BECKFIELD, STATION ROAD, ANDOVERSFORD

FLOOR/WALL DETAIL

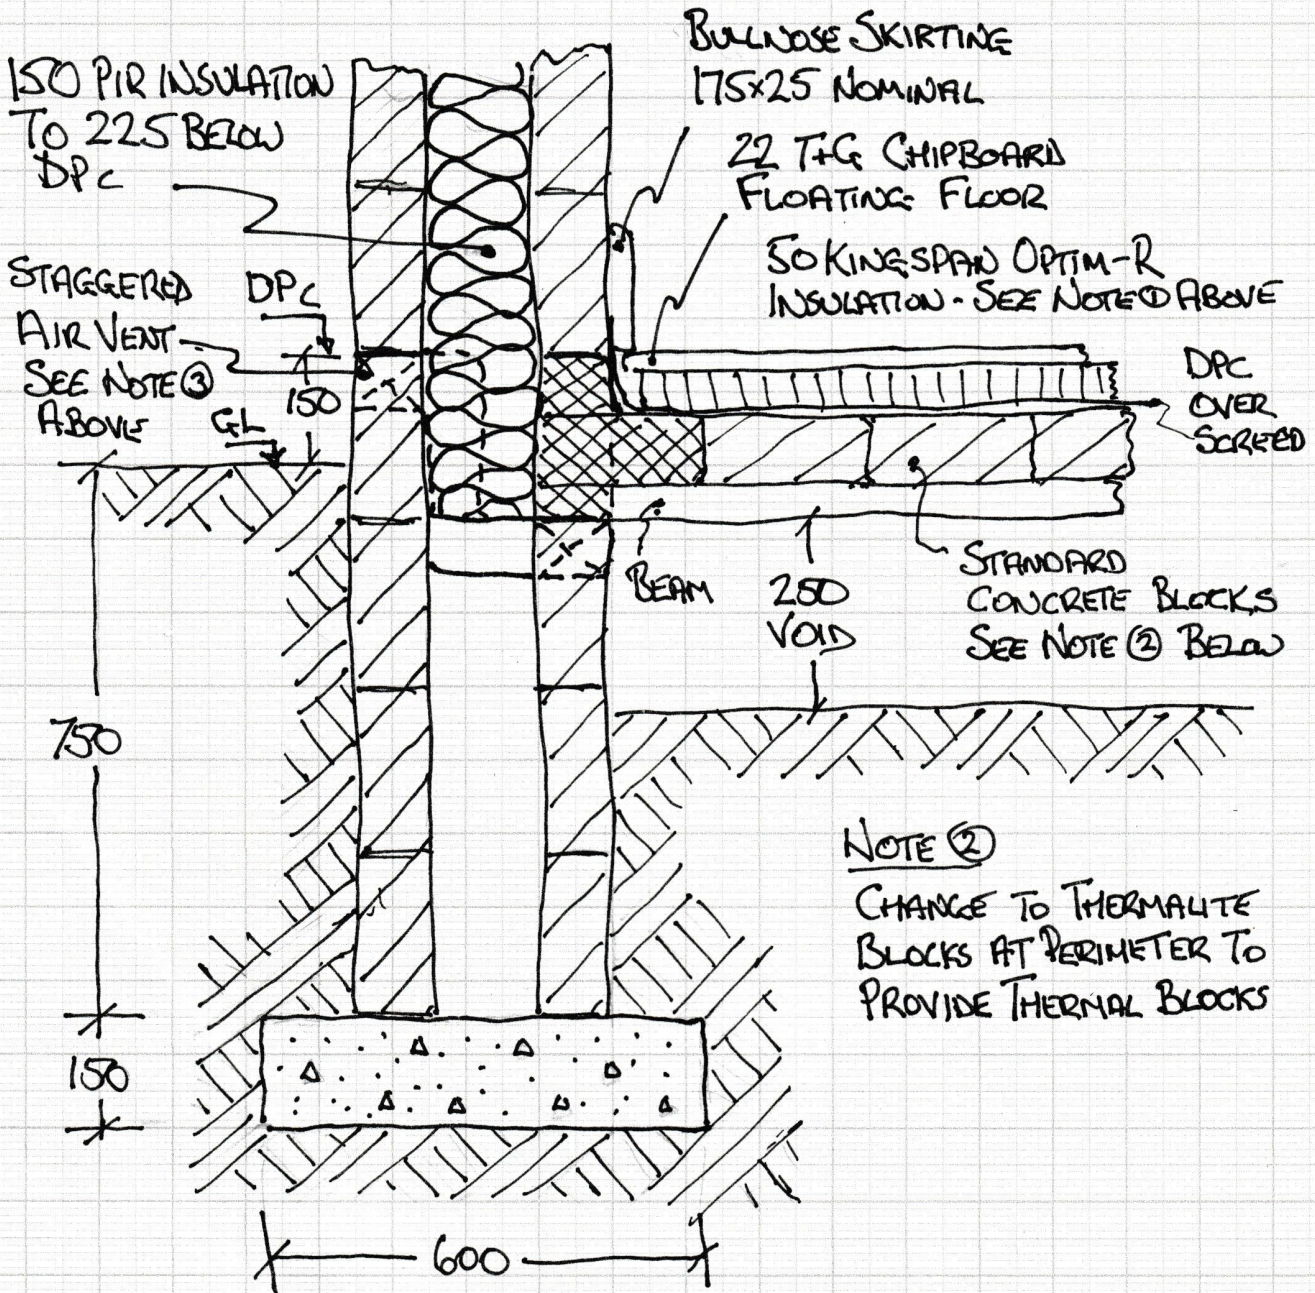
NOTE ③

NOTCH CONCRETE BLOCKS TO RECEIVE AIR VENTS BETWEEN FLOOR BEAMS

NOTE ① (2 PARTS)

- ④ 50x25 BATTEN ON EDGE REQUIRED AT DOOR THRESHOLDS
- ⑤ 500 MICRON SLIP LAYER REQUIRED UNDER FLOATING FLOOR

NOTE ②

CHANGE TO THERMALITE BLOCKS AT PERIMETER TO PROVIDE THERMAL BLOCKS
